Designation: **B820—14a B820 – 18**

## Standard Test Method for Bend Test for Determining the Formability of Copper and Copper Alloy Strip<sup>1</sup>

FIG. 2 V-Block and Punch for 90° Bend Test

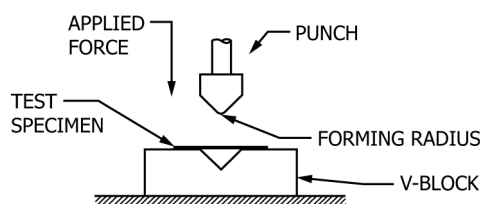
6.1.1 *90° Bend Test Fixture*—An illustration of this test fixture is shown in Fig. 2. A specimen rests on a pair of pins, rollers, or radiused flat supports; a pin, mandrel, or 90° V-block punch of a given bend radius for applying the bending force directly at the mid-length.
